COMMITTEE OF THE WHOLE NOVEMBER 21, 2005

**ZONING BY-LAW AMENDMENT FILE Z.05.033
SITE DEVELOPMENT FILE DA.05.030
1541677 ONTARIO INC.**

Site Plan

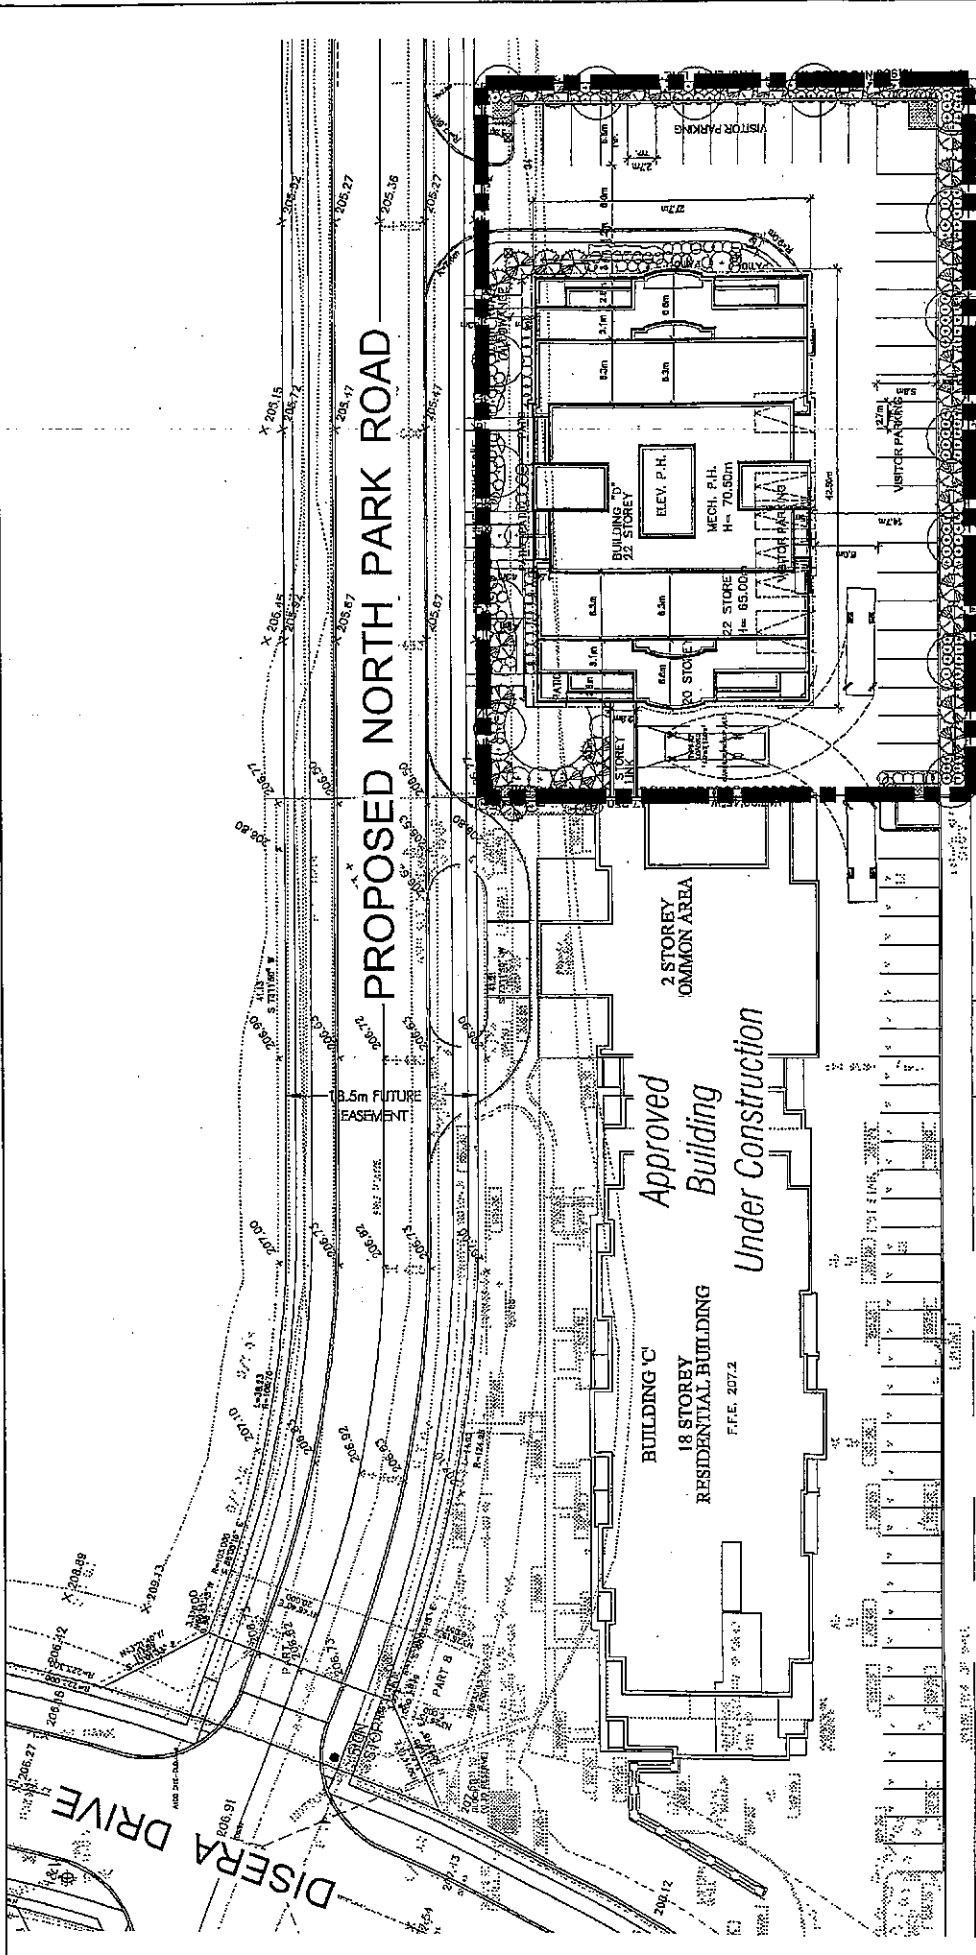
- i) a minimum front yard (north) setback of 6m is required, whereas 4.3m is being provided;
- ii) a minimum front yard (north) landscape strip of 6m is required along the street line, whereas 4.3m is being provided;
- iii) the maximum building height is 65m. Which is being maintained to the top of the parapet, however a variance is required for the architectural design element above the mechanical penthouse, which constitutes part of the building height, and will exceed the maximum permitted height from 65m to 83.1m;
- iv) a total of 305 parking spaces are required, whereas 301 parking spaces are being provided; and
- v) access to the underground parking is being provided from an entrance in the adjacent Building "C", whereas the by-law requires access to parking areas to be from the subject lands.

The Site Plan (Attachment #3) consists of a 22-storey, 231 unit residential condominium apartment building, which steps down to the 21st, 20th, and 19th floors along the east and west elevations. The proposed development is connected to Building "C" to the west by a two-storey common area, which serves both buildings. The common area/lobby will facilitate direct drop-off and pick-up access from the future North Park Road to the main lobby area. A second access to the site is from the future North Park Road at the eastern limit of the site and provides access to visitor parking, garbage pick up and loading areas, as well as, the ramp to the underground parking garage which is located on the southeast corner of the adjacent westerly Building "C", providing access to 262 underground spaces below Building "D". Access to the site can also be obtained from Disera Drive through the adjacent westerly Building "C" lands.

The proposed development comprises 301 parking spaces, resulting in a deficiency of 4 parking spaces, (1.31% deficiency), which is minimal.

Landscape Plan

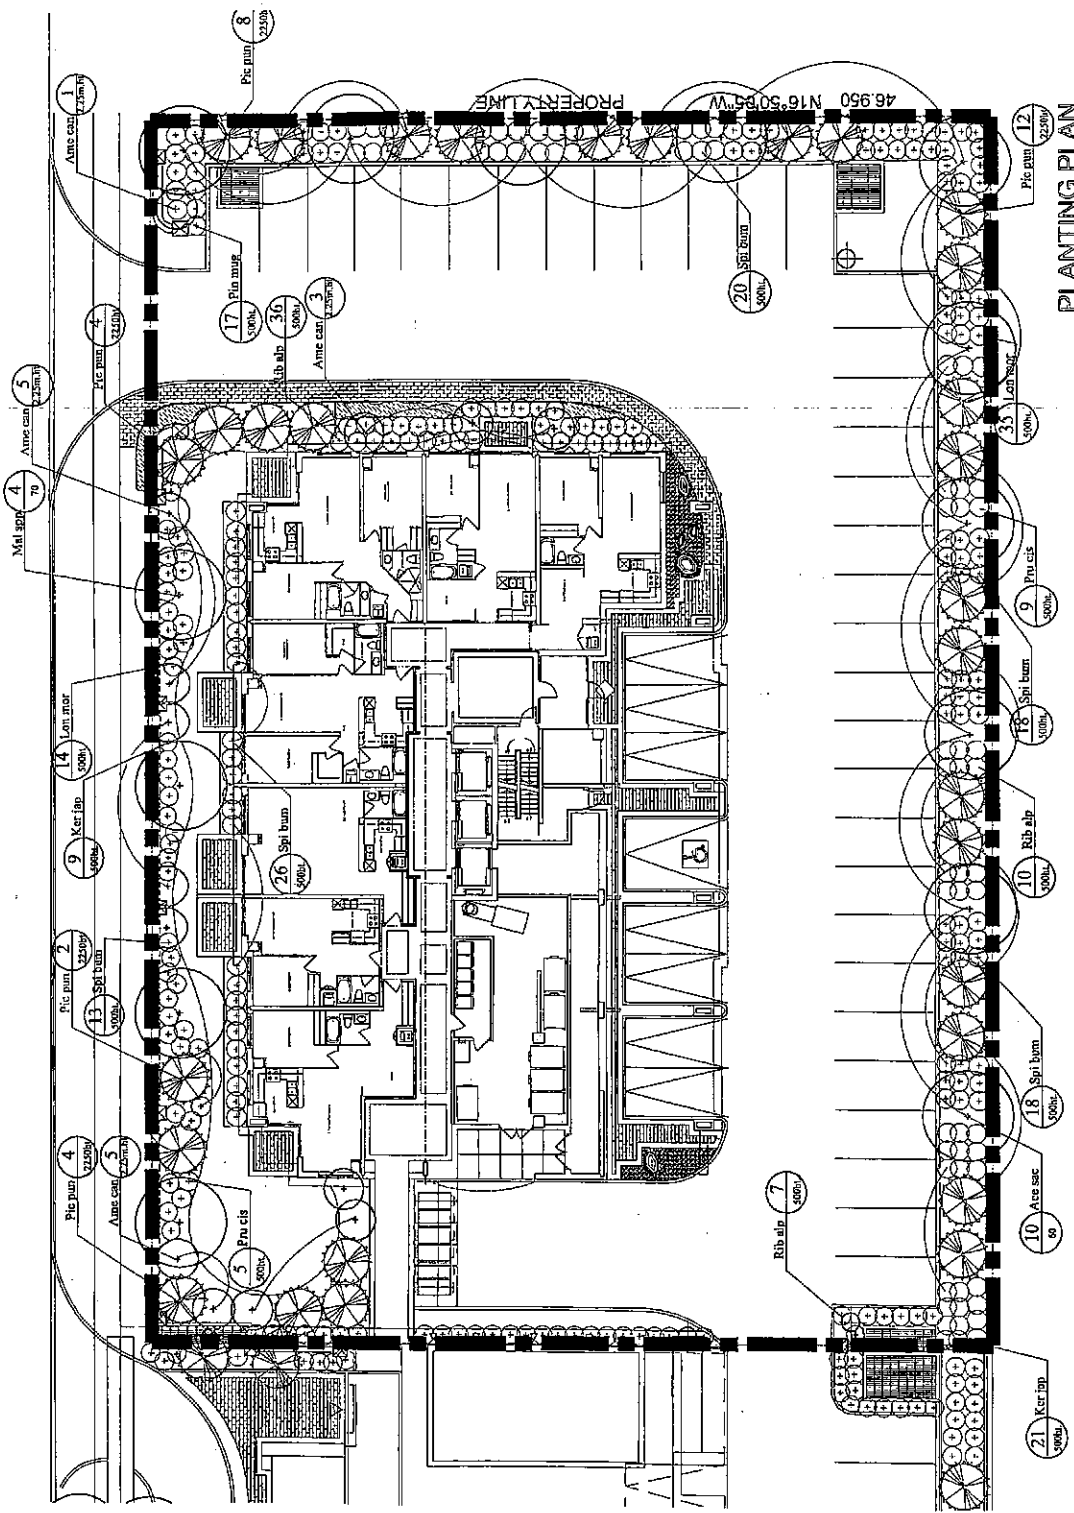
Development Planning Department has reviewed the landscape plan will require the applicant to address the following matters on the final plan: snow storage locations, alternative tree species, patio screening between ground floor units, lighting plan, and additional grading details to verify if a retaining wall will be required along the south property limit, and if so, design treatment of the wall. The final landscape plan shall be approved to the satisfaction of the Development Planning Department.
